Service Bulletin

Bulletin No: JC-016-10

Issue: Engine shuts down immediately and will not restart

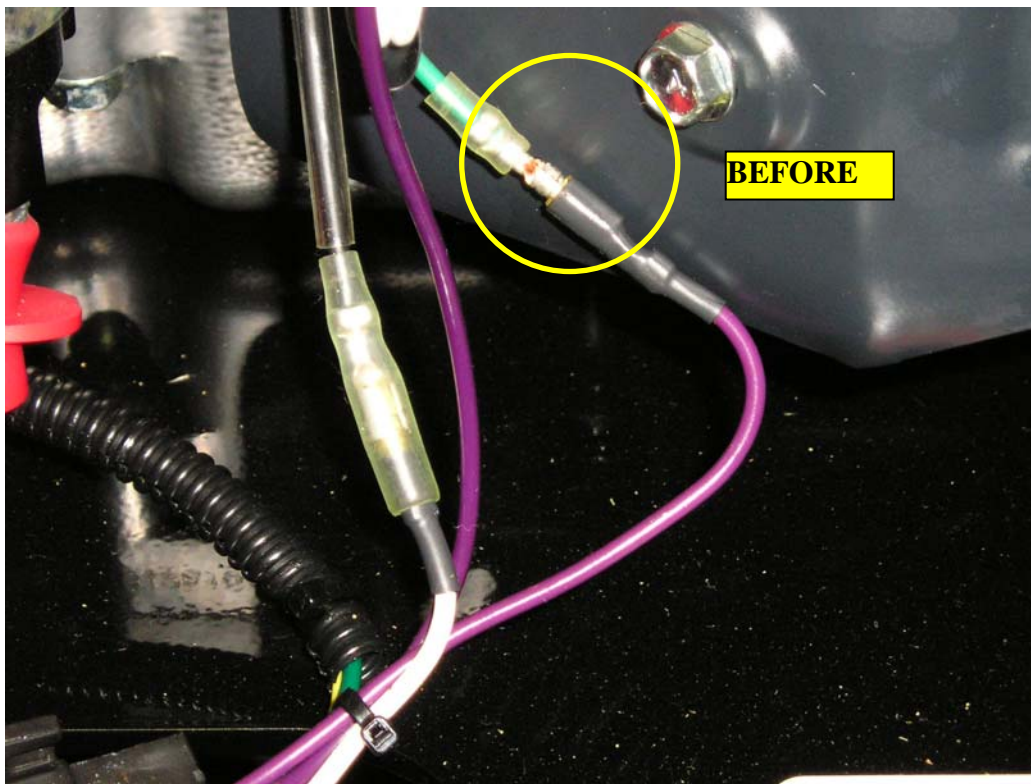
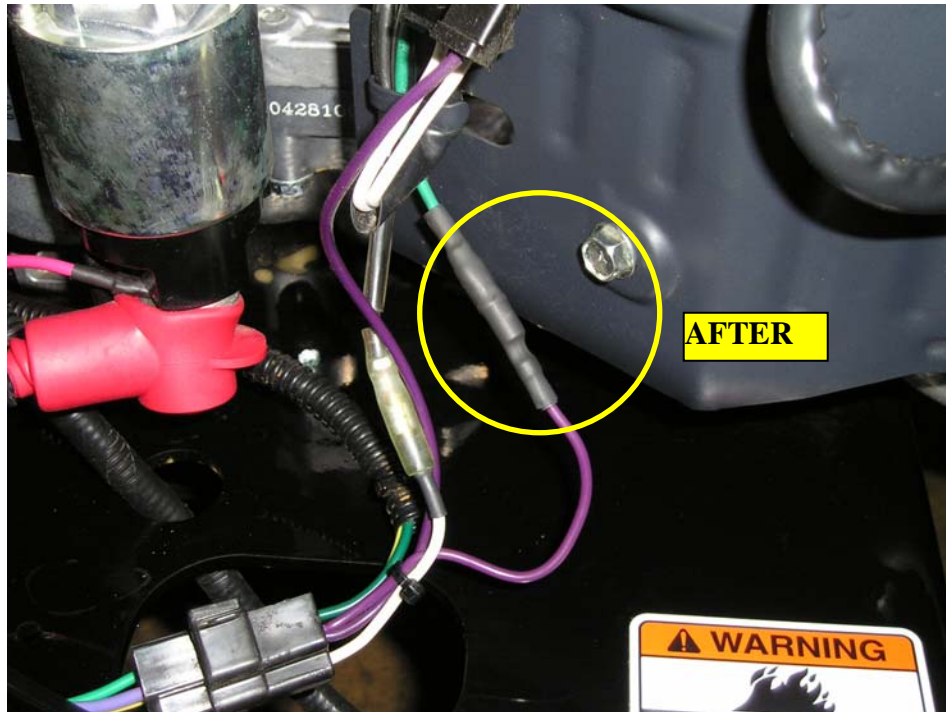
Cause: Wiring harnesses were manufactured without the required boot over the female spade on the (purple) wire to the carburetor solenoid. This exposed connection can touch ground, blowing the fuse on the charge circuit (purple wire fuse holder). The solenoid then shuts off all fuel supply to the engine causing unit to shut down, and not re-start.

Action Required: Pull the wire apart at the connection, slip a 2 inch piece of heat shrink tubing over the wire, reconnect the wire, slide the heat shrink tubing over the connection and heat it to shrink it in place. Replace fuse.
